May 6, 1985  
ST-HL-AE-124C  
File No.: G4.2, G9.17, C13.5.3

South Texas Project  
Units 1 & 2  
Docket Nos. STN 50-498, STN 50-499  
Main Cooling Reservoir Meeting

SOUTH TEXAS PROJECT  
MAIN COOLING RESERVOIR

FIGURE 5

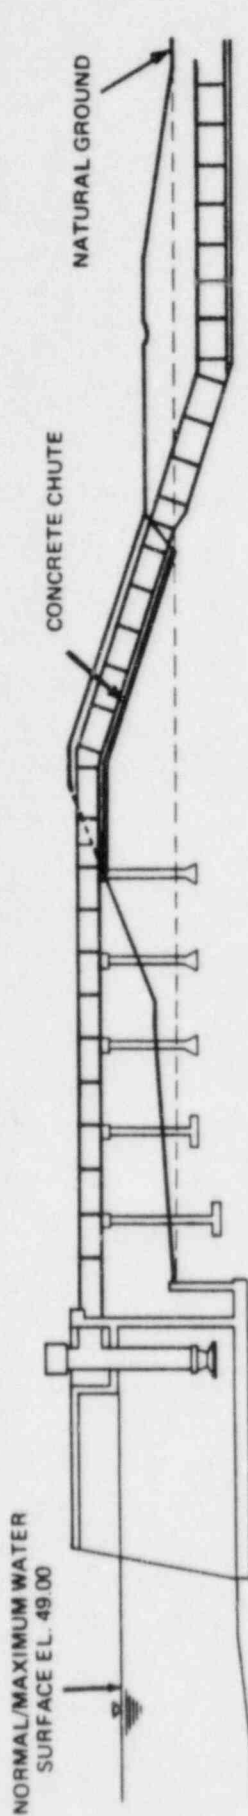
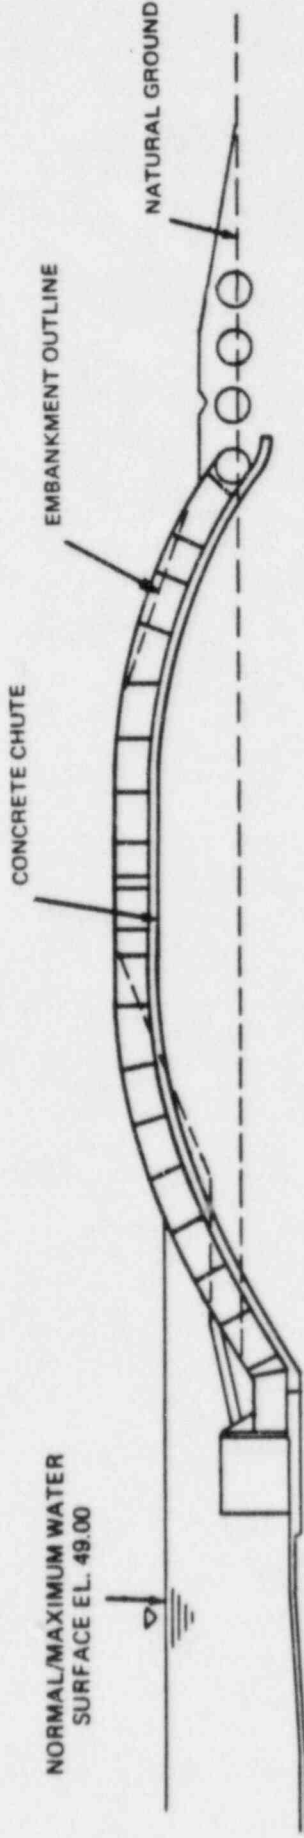
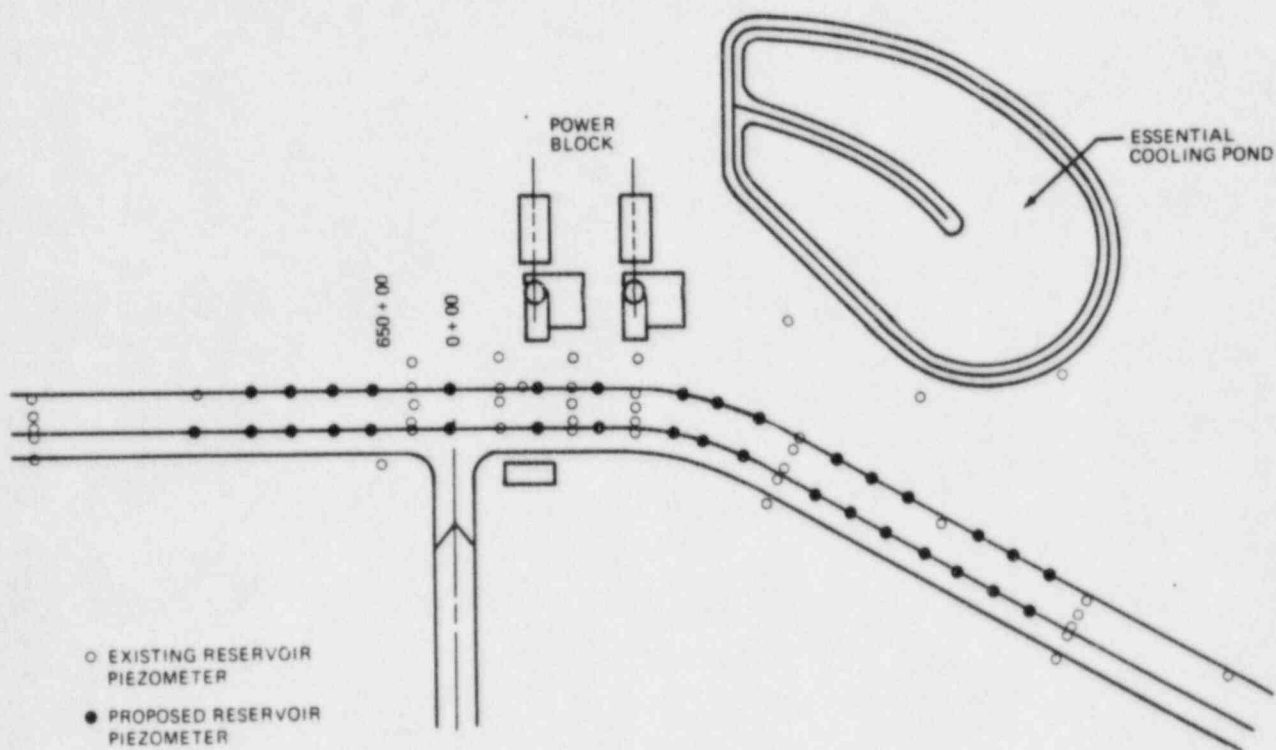
The circulating water system intake and discharge pipes penetrate the embankment section adjoining the power block (Figure 4). During the initial evaluations of the MCR embankment, a concern relative to potential joint leakage and embankment erosion was identified.

The major concern identified by the CRB relates to the watertightness of joints in the pipe sections penetrating the embankment under embankment settlement and hydraulically-induced longitudinal movement. The pipe joints under these loads could open causing leakage which could lead to embankment failure by erosion or by static overstress due to high pore pressures.

As part of their evaluation, Harza studied the pipe penetrations and possible remedial measures to eliminate the erosion concern (Reference 6-1). Their recommendations for the circulating water intake and discharge pipes are summarized below (Figure 5):

- o Expose the circulating water pipes at embankment crest and slopes to provide inspectability of joints.

- o Use new concrete pipes supported in concrete chutes to provide erosion protection.
- o Install additional piezometers along the existing pipes at the toe berm to monitor the performance.

# INTAKE STRUCTURE

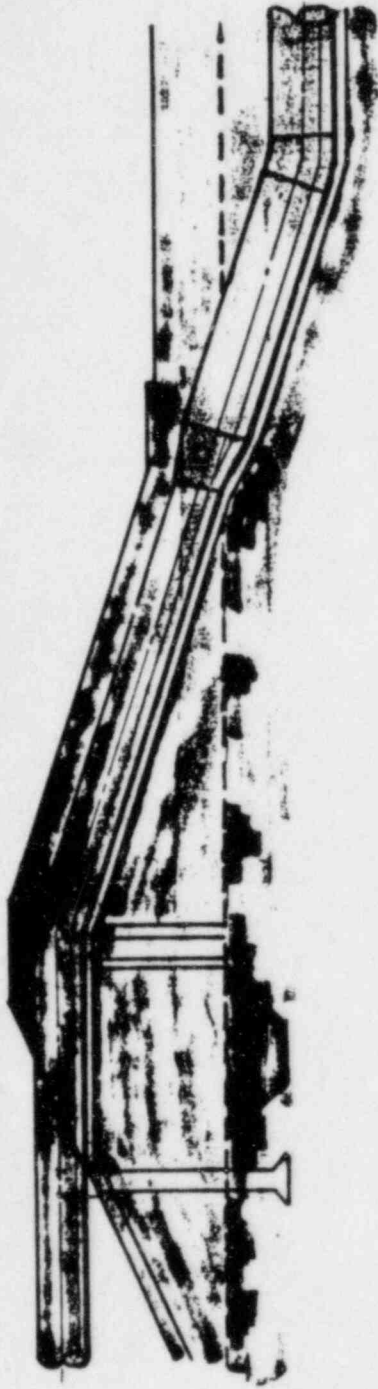
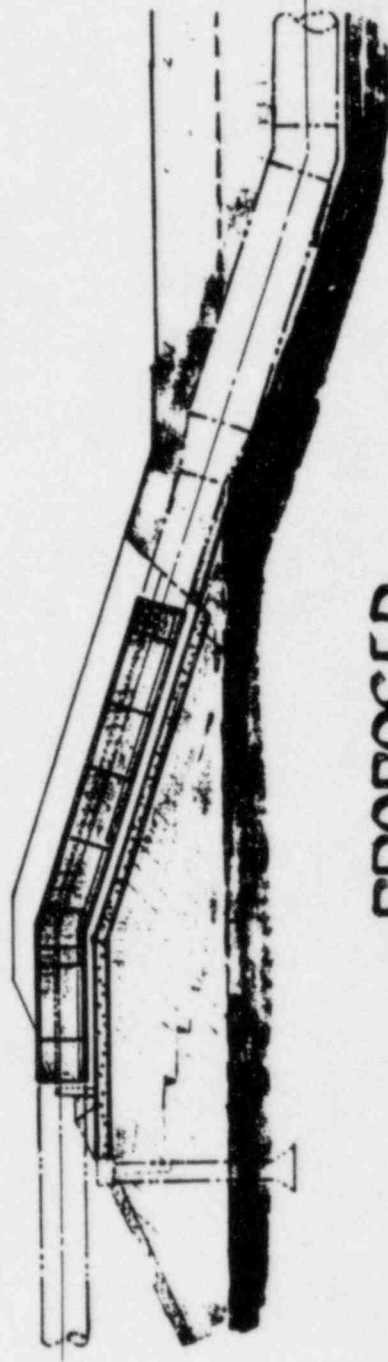
- SEEPAGE FROM RESERVOIR ALONG SAND PIPE BEDDING
- JOINT OPENING DUE TO:  
EMBANKMENT SETTLEMENT  
HYDRAULIC THRUST
- LACK OF INSPECTABILITY - PIPES ARE BURIED

- JOINT OPENING DUE TO SETTLEMENT OR HYDRAULIC FORCES UNLIKELY
- WATERTIGHTNESS NOT GUARANTEED
- LACK OF INSPECTABILITY-MAJOR PROBLEM
- INCREMENTAL FLEXIBILITY OF EXISTING PIPES POSITIVE DESIGN IF INSPECTABLE
